Matthew Rosel - Submission Details for

Submission for Job: #6010 SSD 6010 - One Residential Building (Student Accommodation) within Darling Drive Plot

SSD 6010 – One Residential Building (Student Accommodation) within Darling Drive

LEVEL 6

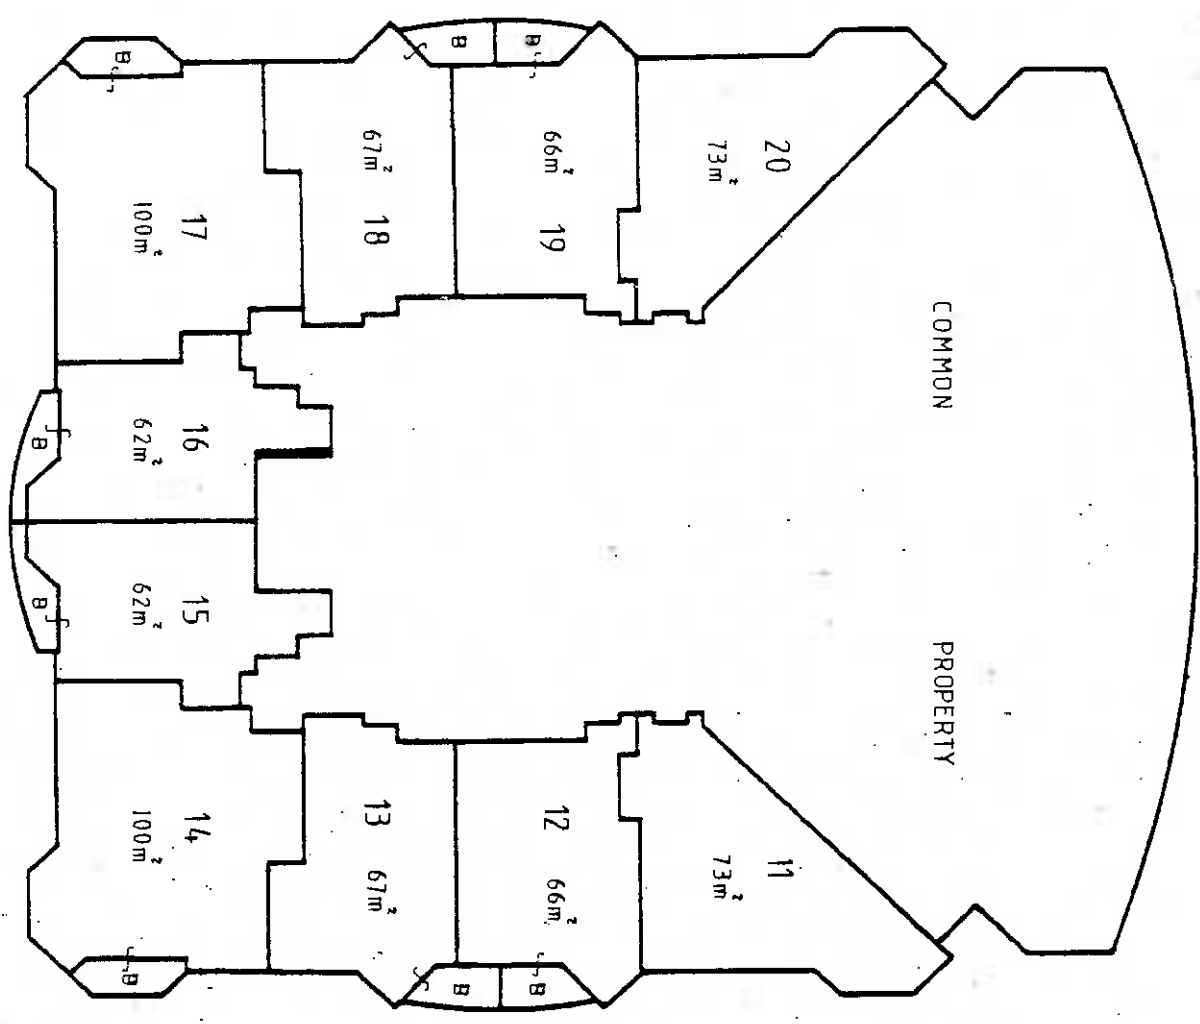
Levels 6 and 7 each contain two apartments with single west aspect , i.e. 4 single aspect apartments.

LEVEL 8

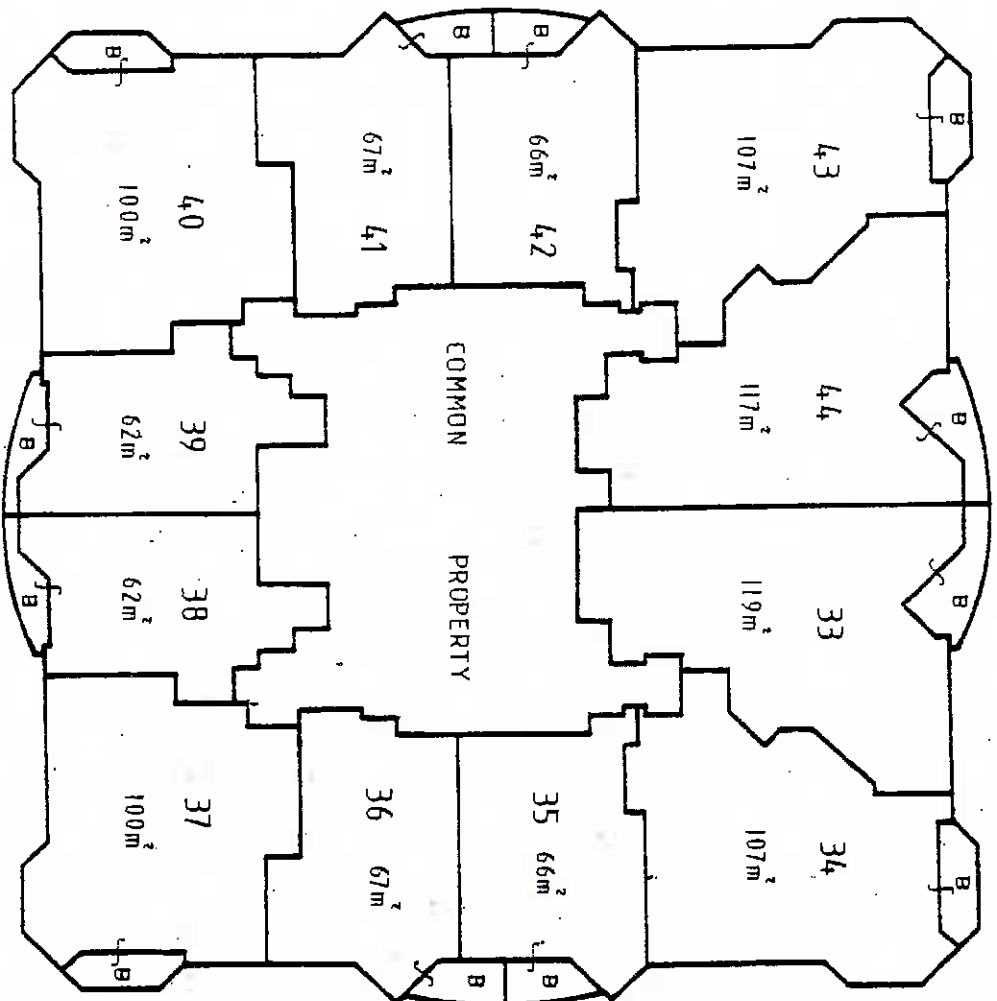
Levels 8-15 each contain two apartments with single west aspect and two apartments with single north aspect , i.e. 4 single aspect apartments per level, giving 32 single aspect apartments.

LEVEL 39

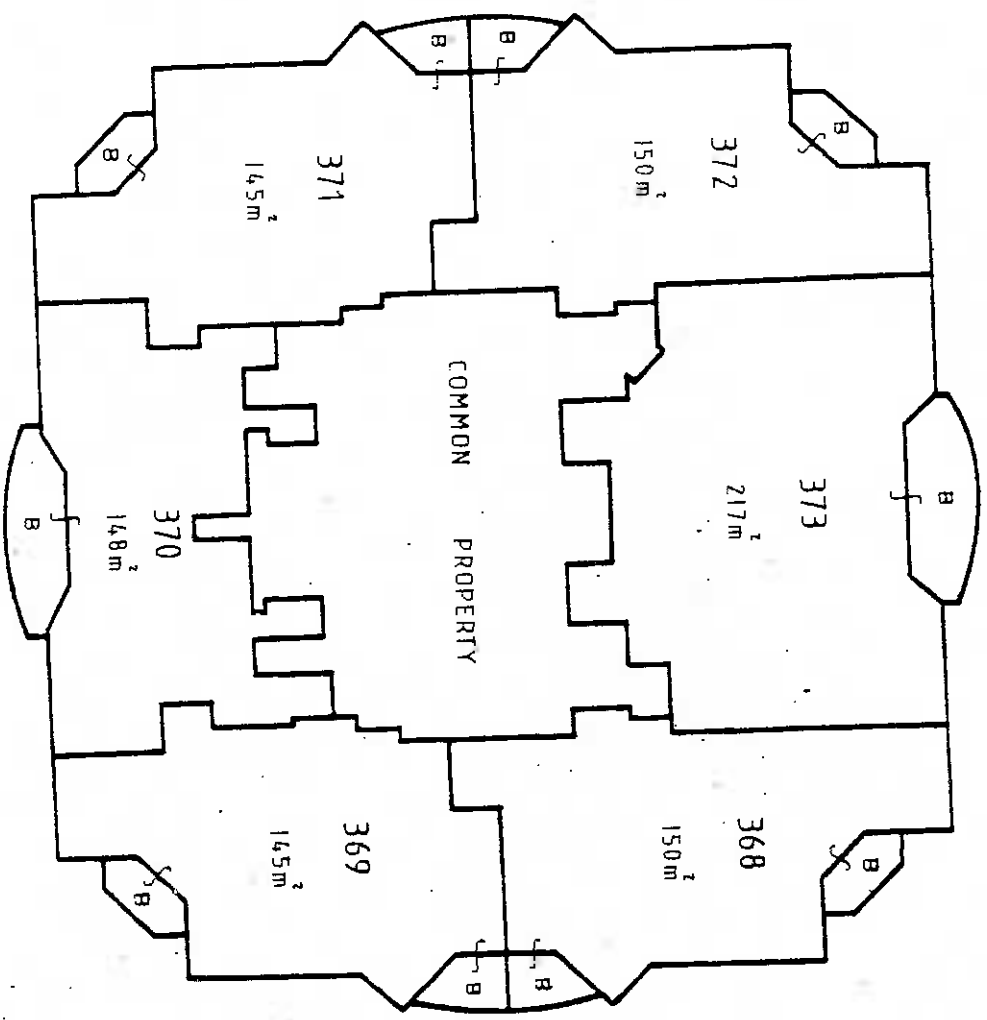
Levels 39-43 each contain one apartment with single north aspect, i.e. 5 single aspect apartments.
